East Anglia TWO Offshore Wind Farm

Appendix A23 to the Natural England Deadline 11 Submission

**Natural England's Response to London Array OWF Year 3 Ornithological
Monitoring Report**

Planning Inspectorate Reference: EN010078

Figure 6 Red-throated diver mean density (birds/km²) within the SPA, excluding the areas within the footprints of wind farms (SPA (-WF)), and within those windfarm footprints (WF) for Survey 1 and Survey 2.

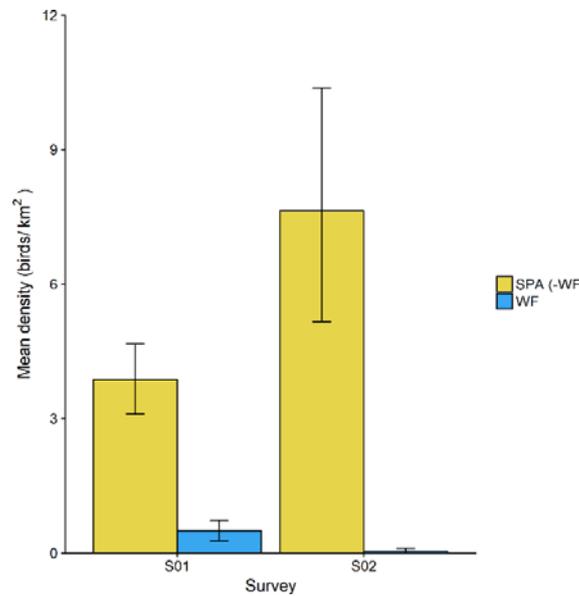
strong displacement of red-throated divers from areas within offshore windfarms and from areas of shipping activity. This has led to higher densities of birds at points furthest from anthropogenic activity. This can be seen visually in the number of diver detections and the modelled diver density surface shown in Figure 8 of Irwin et al (2019) and in the pronounced difference in diver density between areas inside windfarm footprints within the SPA and areas outside those footprints as shown in Figure 6 of Irwin et al (2019). These figures are reproduced below:

These surveys indicate that displacement of red-throated divers from LAW and its immediate surroundings continued to be detectable in early 2018 – two years after the conclusion of the post-construction monitoring programme at LAW, and four and a half years after LAW was fully commissioned.
